ACN-20240206 TE0701-07 CameraLink removal

Company	Trenz Electronic GmbH
ACN Number	ACN-20240206
Title	CameraLink removal
Subject	Upcoming Changes
Issue Date	2024-02-07

Affected Product
TE0701-07*

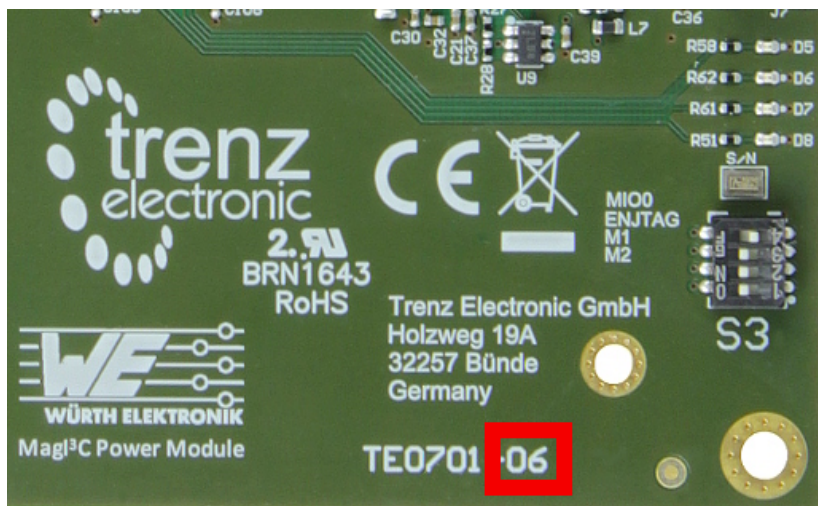
#2 Changed FMC connector (J10) from LPC to HPC to use connections from CameraLink Connector (J3).

Type: Schematic Change

Reason: CameraLink connection usage.

Impact: None. HPC connector is backward compatible to LPC connector.
